From: Michael Stephenson <mstephenson@cameron-cole.com>
Sent: Friday, September 26, 2014 1:03 PM
To: Jump, Christine
Cc: SMITH, MARTIN L
Subject: RE: Underslab sample results for Building B, D and Process Area
Attachments: Concrete Disposal Extent.pdf

From: Michael Stephenson [<mailto:mstephenson@cameron-cole.com>]
Sent: Wednesday, September 24, 2014 3:43 PM
To: Jump, Christine
Cc: Akhter Hossain; SMITH, MARTIN L; mkamal@kdheks.gov; Brady Gerber; sklaus@geostatenviromental.com
Subject: Underslab sample results for Building B, D and Process Area

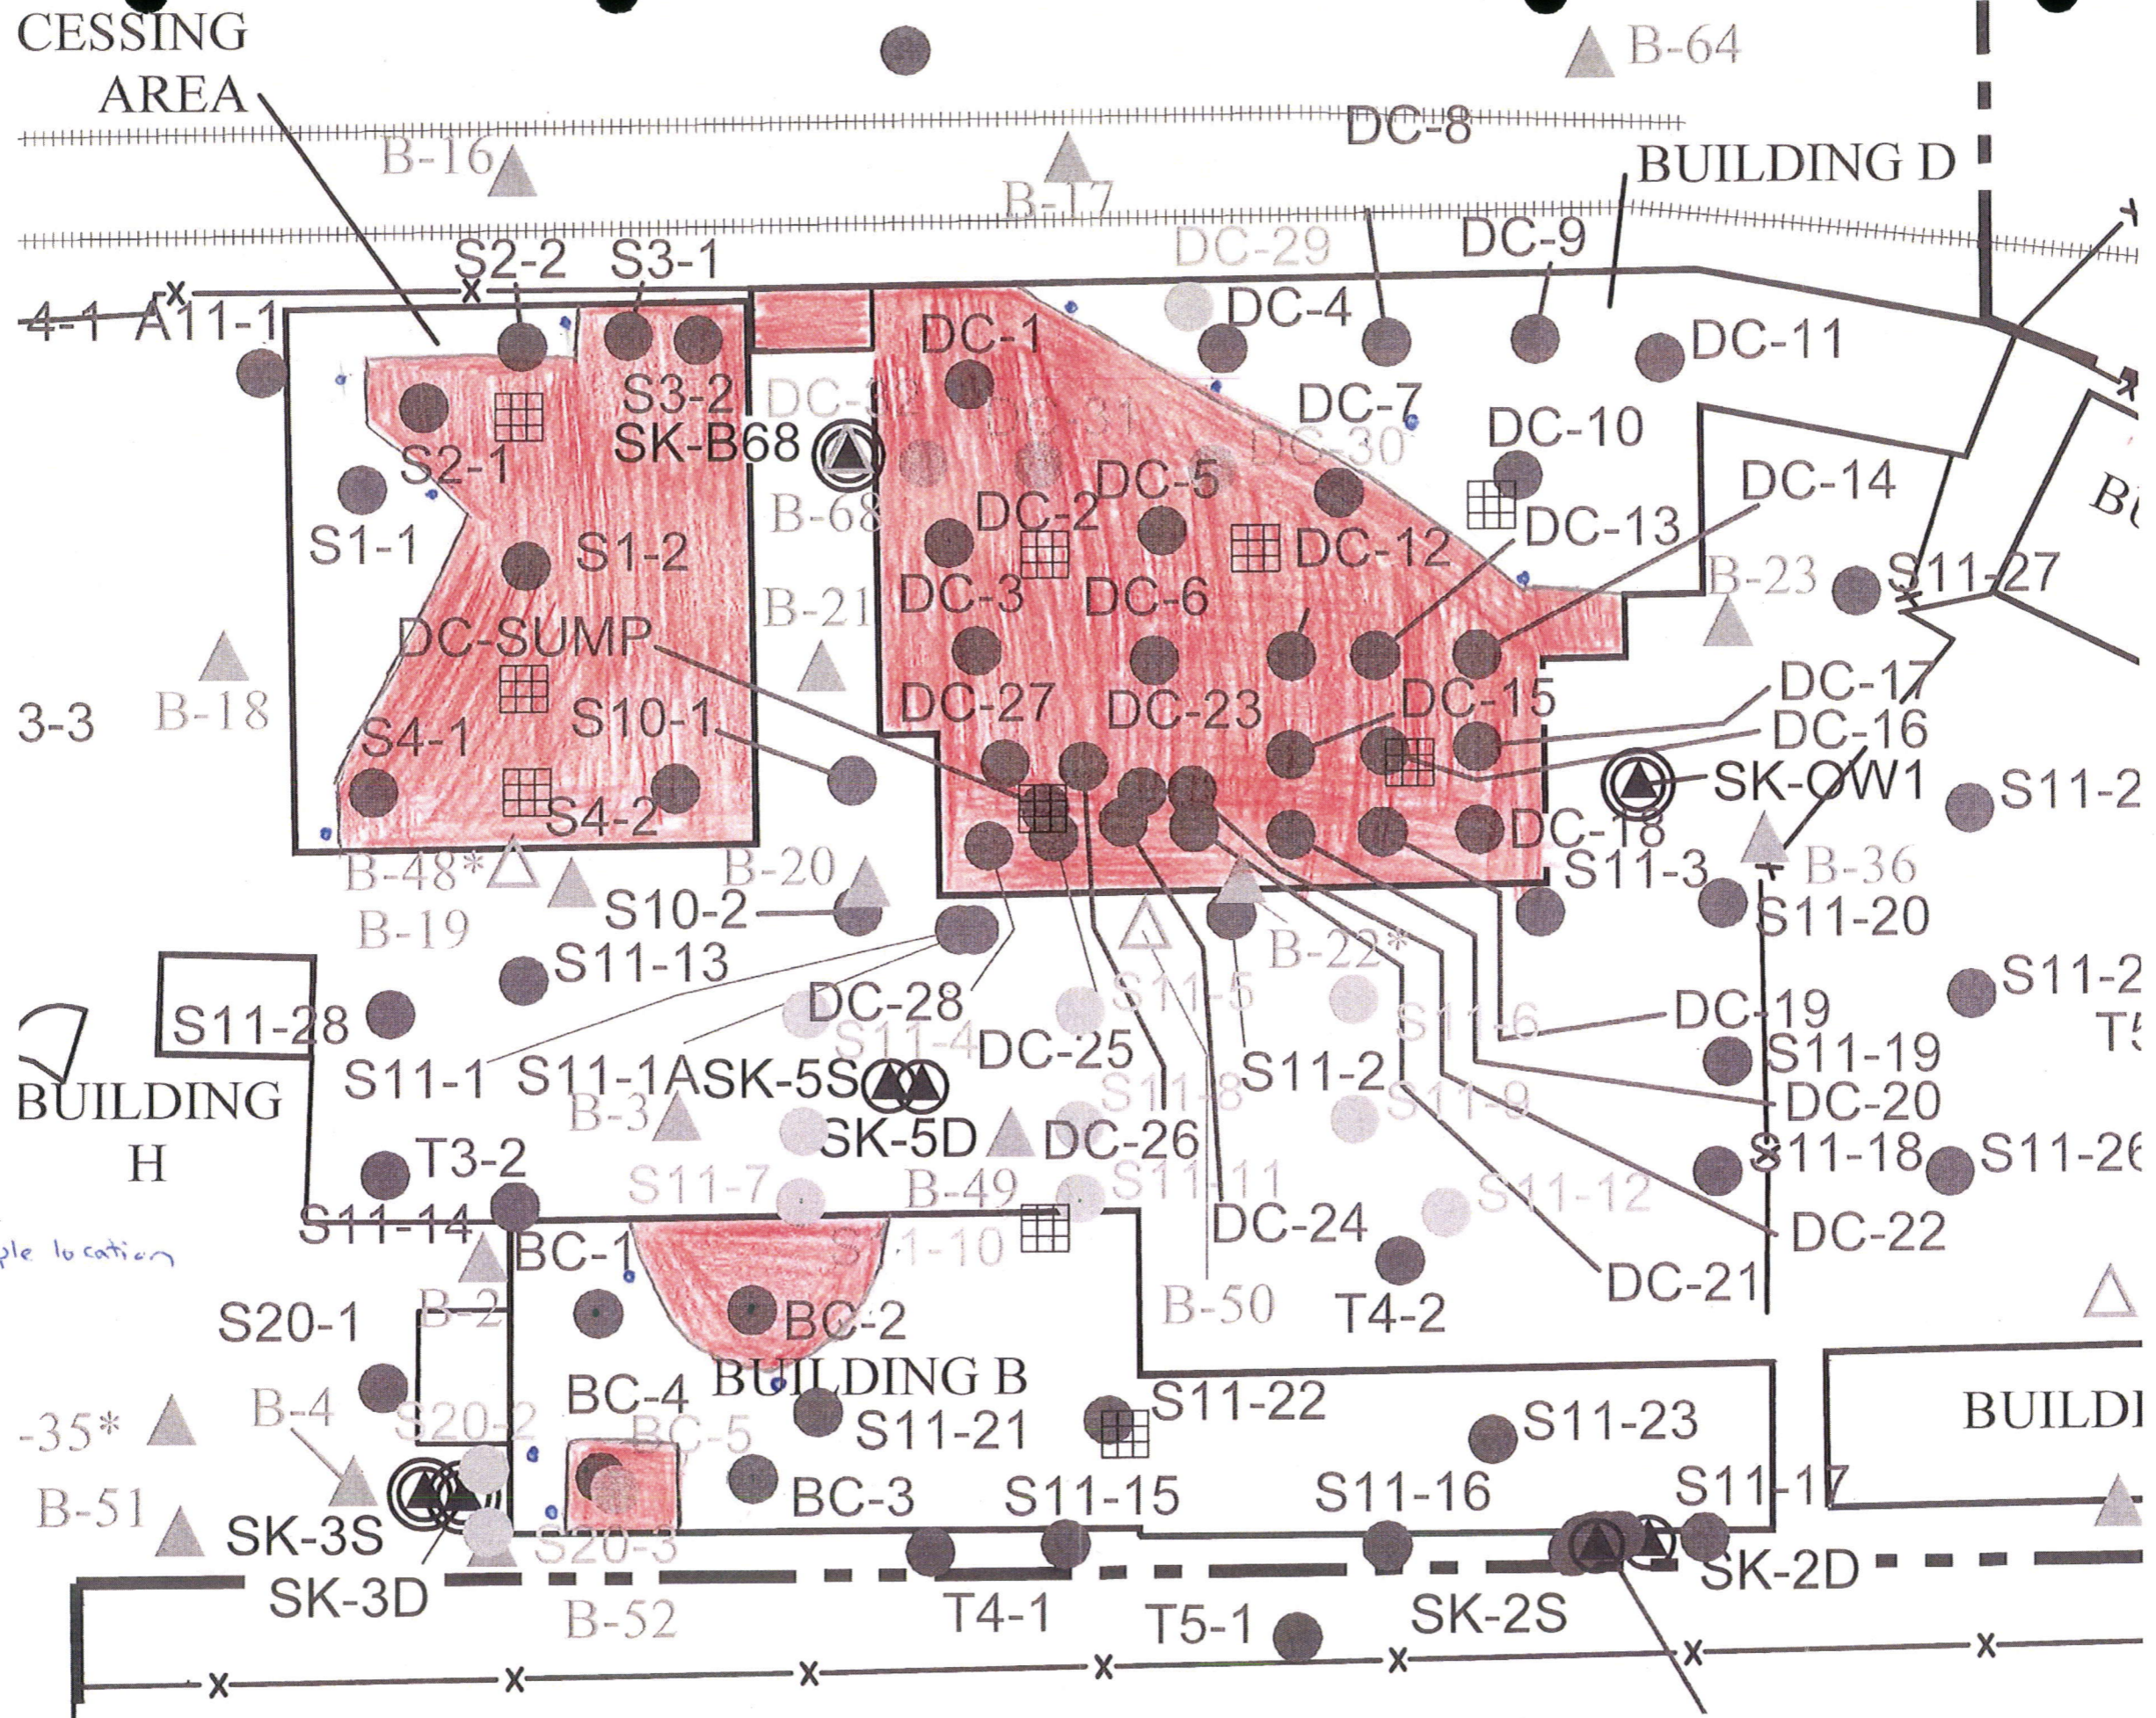
Can you submit figures of the buildings that delineate the areas of concrete you intend to re-use and the areas you intend to send offsite for disposal? The figures can be hand drawn if you like, but I would like something in the file that

shows where samples were collected and the decisions concerning concrete that are based on those samples. Give me a call tomorrow morning if you would like to discuss this,

Attached please find the requested figure which depicts the portions of the concrete floor that will be disposed or re-used as backfill. This follows very closely our original layout and is supported by the recently collected underslab sample data.

As shown in the Table, all results were below IAOs. As such, we plan to proceed with re-use of the concrete overlying the clean soils as originally proposed in the rinsate package submittals.
